METROPOLITAN GOVERNMENT OF NASHVILLE AND DAVIDSON COUNTY

STAFF RECOMMENDATION
3501 Bryon Avenue, Lot 11
February 20, 2013

Application: Infill
District: Elmington Place Neighborhood Conservation Zoning Overlay
Council District: 25
Map and Parcel Number: 10410004700
Applicant: Kevin Smith/ Ransom Avenue 3501, LLC
Project Lead: Robin Zeigler, robin.zeigler@nashville.gov

A1.3

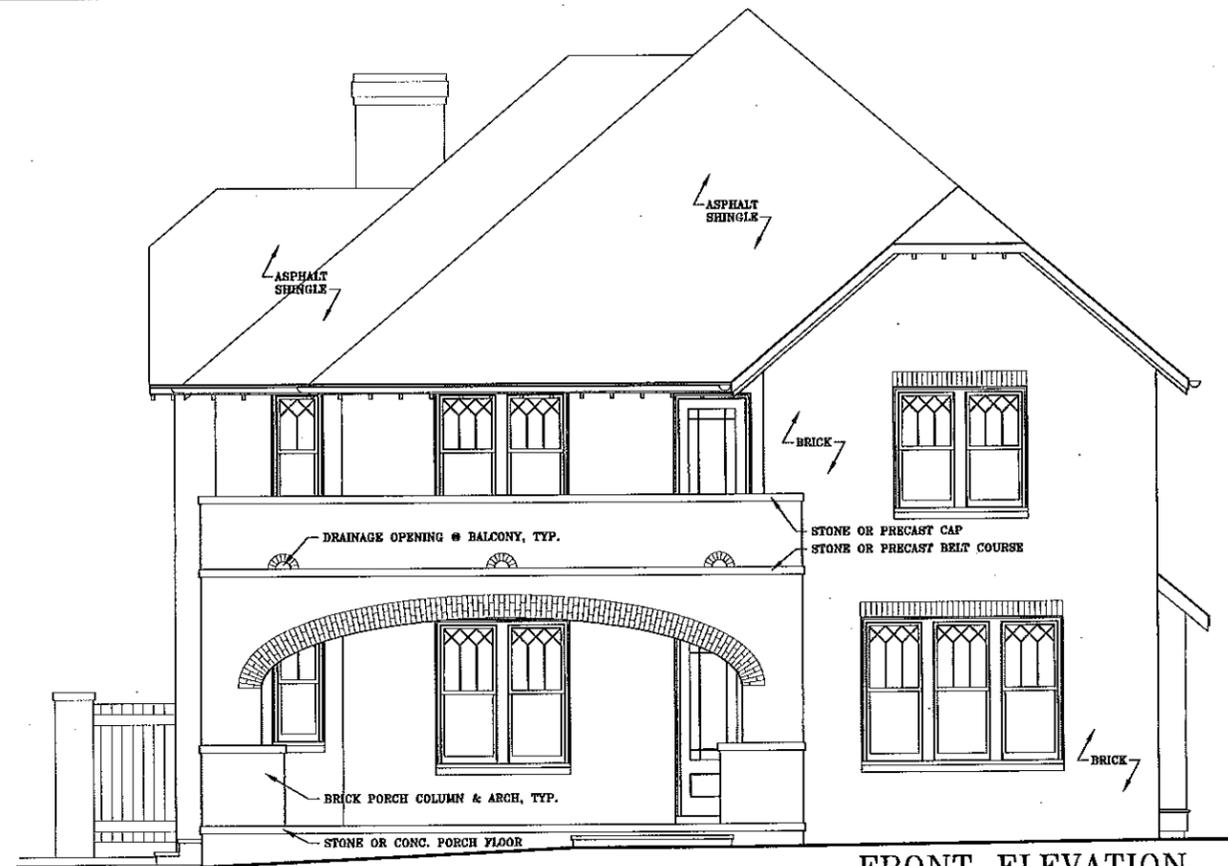
Roof Shape: The proposed shape is a cross clipped-gable and hipped roof. Hipped and side gable roofs are what are typically found on two-story buildings in the overlay. Individually these two forms are found in the district but not crossed. Staff finds the more complicated form for this corner lot to be appropriate as it allows for the side entrance to appear as a primary entrance, even though the true entrance is on the new Ransom Avenue. Simpler forms matching those found in the overlay are recommended for interior lots. Clipped gables are rare but are found on at least one historic home in the overlay. The primary roof slopes is 10/12, which is a typical slope for the overlay. Staff finds the project to meet section II.B.e of the design guidelines.

A2.1

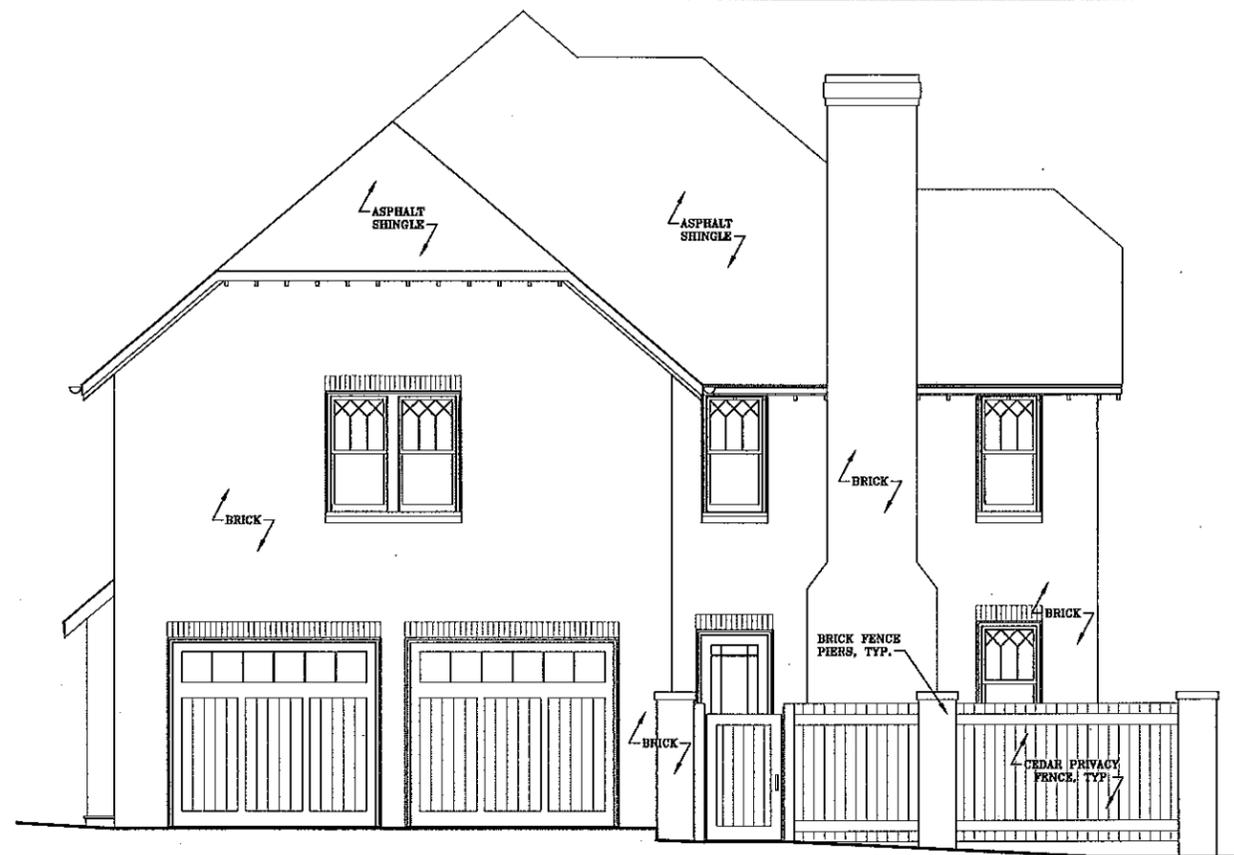
Height & Scale: The proposed building is two-stories with a foundation height that varies because of the grade but is approximately one foot (1') tall at the highest point. The majority of homes in the neighborhood are one-story but there are several two-story homes. The massing of all homes in the overlay are mitigated by changing materials between the foundation and wall. Staff recommends either changing the foundation material or using a highly contrasting brick color to delineate the foundation.

The eaves are approximately nineteen feet (19') and the ridge is approximately thirty-five feet (35') from the finished floor line. Two-story homes in the vicinity range between twenty-eight feet (28') and thirty-six (36') tall from grade. This places the home

The porch roof is approximately sixteen feet (16') tall from finished floor and includes a one-story flat roof with parapet wall. The majority of porches in the overlay are gabled and do not use the upper level as active-space; however there is one example of a flat roof porch with railing above. See 202 Elmington Avenue to the right.

Orientation: The true orientation of the building is facing the new Ransom Avenue. The corner lots of this development visually contribute to the historic context more than the interior lots. Utilizing a wrap-around porch and two doors, this home has what appear as two primary entrances, one facing the new Ransom Avenue and one facing Richardson Avenue, which allow it to match the orientation of the existing buildings along Richardson Avenue. There is a concrete walkway leading from the porch to the new Ransom Avenue and staff recommends a similar walkway leading from the porch to Richardson Avenue.

Porches are generally required to be a minimum of six feet deep to avoid faux porches that really aren't usable. This porch is seven feet and one inch (7' 1") facing the new Ransom Avenue and five feet and three and one half inches (5' 3.5") facing Richardson Avenue. Although the porch depth on Richards does not quite meet the minimum the difference is negligible and the idea of a "usable porch" is accomplished with the section facing Ransom Avenue.

With the condition that a walkway be added from the porch steps on the Richardson Avenue side of the porch to Richardson Avenue, the project meets section II.B.f of the design guidelines.
